AGENDA
City of Gig Harbor Design Review Board
Virtual Meeting of December 9, 2021 at 5:00 pm

**COMMUNITY DEVELOPMENT DEPARTMENT
PLANNING DIVISION
STAFF REPORT**

RE: Cedarbrook Dental (PL-SPR-21-0002 & PL-DR-21-0124)
Public Meeting Date: December 9, 2021

Cedarbrook Dental | PL-DR-21-0124

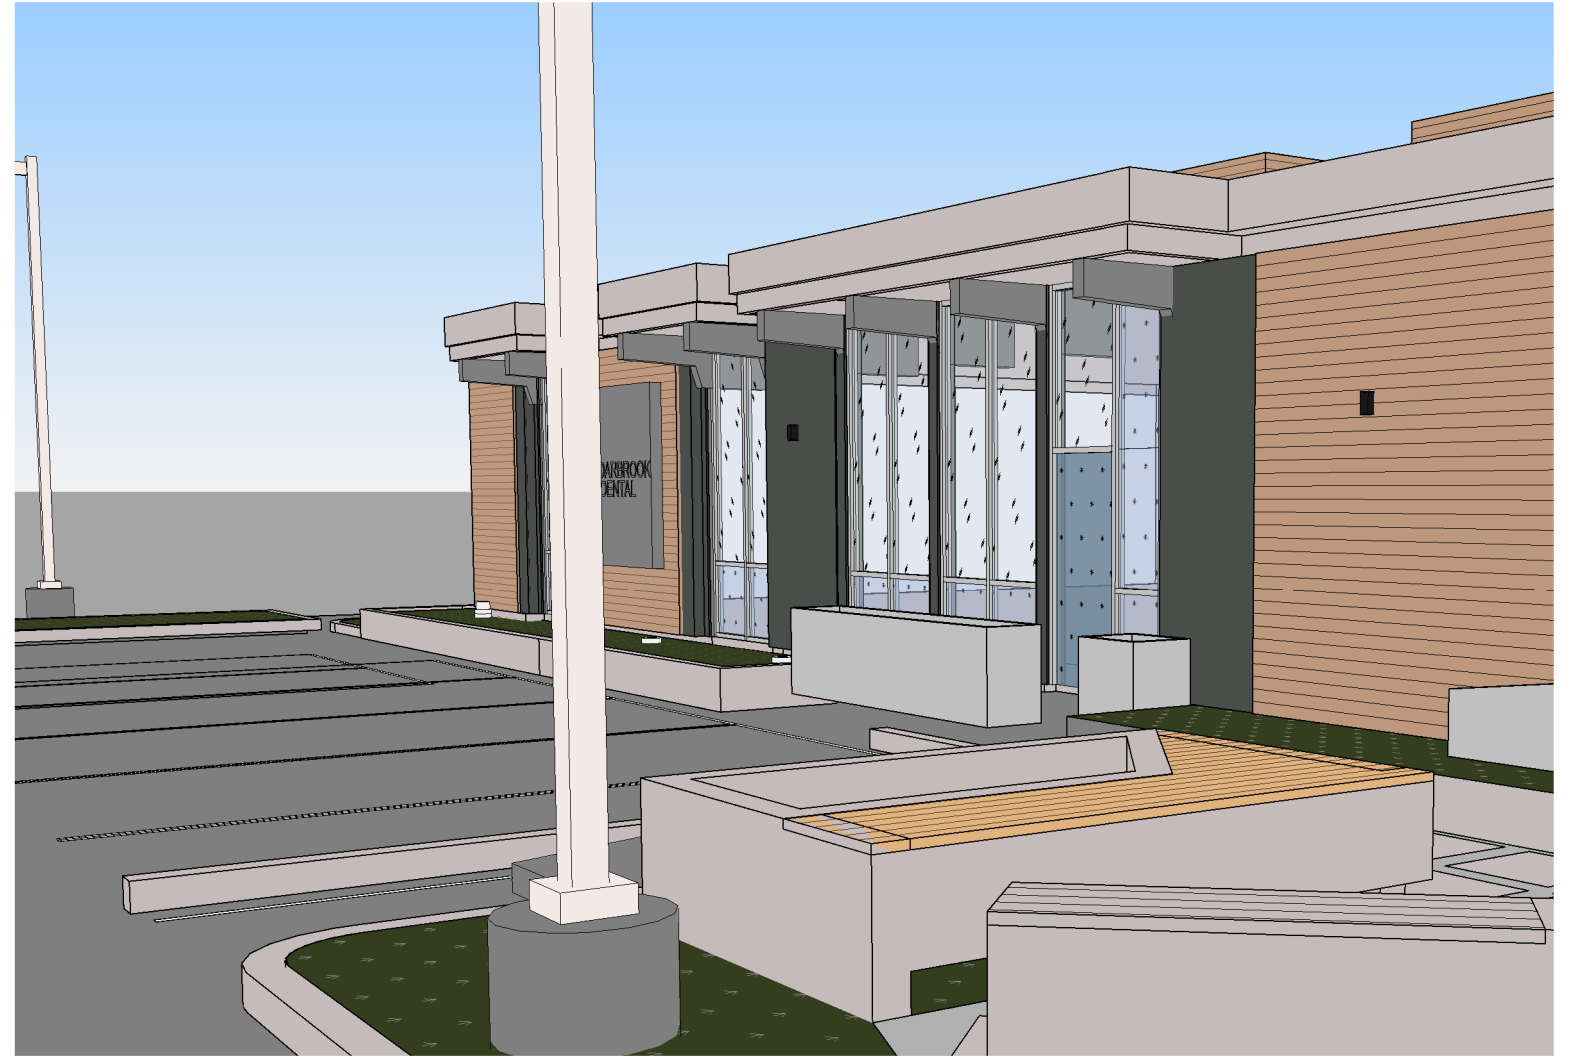
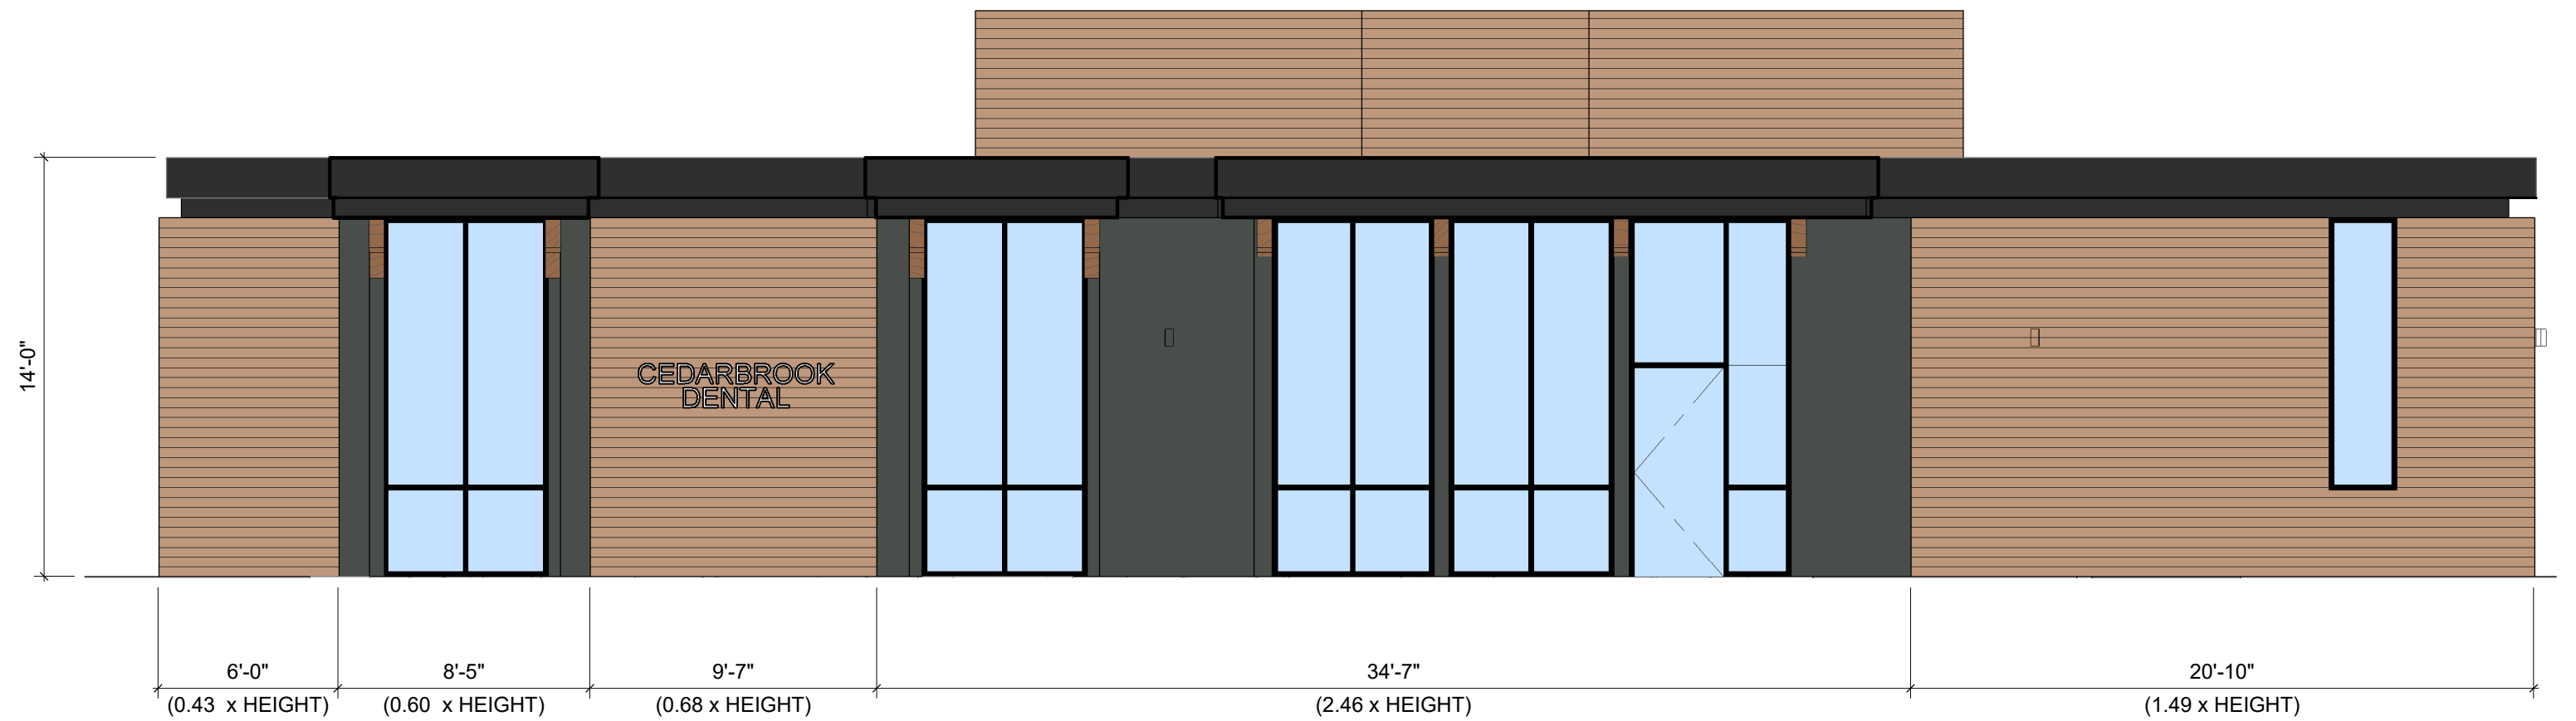
The applicant is proposing to remodel the north façade of the site's existing structure in a manner which creates a long, low wall plane. Specifically, the wall plane on the north façade of the subject structure measures approximately 12-feet in height, and the proposed design will create a continuous wall plane of approximately 79-feet-and-2-inches in length; whereas strict adherence to GHMC 17.99.380(A) would avoid a wall plane that is longer than two and a half times (2.5x) the height of the wall plane, the applicant in this case proposes a wall plane that is approximately six and a half times (6.5x) the height of the wall plane.

In its existing state, the north façade incorporates a 4-foot shift in the structure's footprint; modulation of this design is also inconsistent with GHMC 17.99.380(A), but the existing shifted footprint speaks to the

The subject structure is now being remodeled to facilitate a dental office. Whereas two entrances to a bank are purposeful and functional, the same cannot necessarily be said for a dental office. The applicant is retaining the entrance to the structure that is presently located along the south façade; to retain the current recessed area in the north façade but remove the existing second entrance associated with this recessed area creates an unusable space that can otherwise be enclosed to offer a functional space in the interior of the structure. In light of the increase in functional use of the structure, staff concurs that the applicant's alternative design proposes an equivalent or superior design solution to that of strict adherence to the long, low wall plane standards set forth in the Design Manual.

Furthermore, the applicant's use of a variety of materials in the north façade present architectural interest that may otherwise be absent in a long, low wall plane. The applicant proposes to use both horizontal wood plank and tiled cladding siding materials in the north façade, and also incorporate floor-to-ceiling windows in the façade's design which constitute approximately 37% of the wall plane. The interesting combination of siding materials and the considerable use of glazing provides intrigue to the façade despite the dimensionally long, low wall plane, and by virtue communicates the characterized and unobtrusive development that is intended by the scale and massing standards of the Design Manual (see side panel discussion on page 17-220 of the Design Manual; Exhibit C). As such, the applicant's proposed alternative design achieves a design solution that is equivalent to GHMC 17.99.380(A) and is consistent with the general intent of the mass and scale standards codified in the Design Manual.

3. **Findings:** The DRB finds that the proposed design alternative meets the intent of the general requirement of GHMC 17.99.380(A) and

represents an equivalent or superior design solution to what would otherwise be achieved by rigidly applying the specific requirements of GHMC 17.99.380(A).

4. **Recommendation:** The Design Review Board recommends the decision maker accept the proposed design alternative as compliant with the criteria of approval for an alternative design request set forth in GHMC 17.98.055(A).
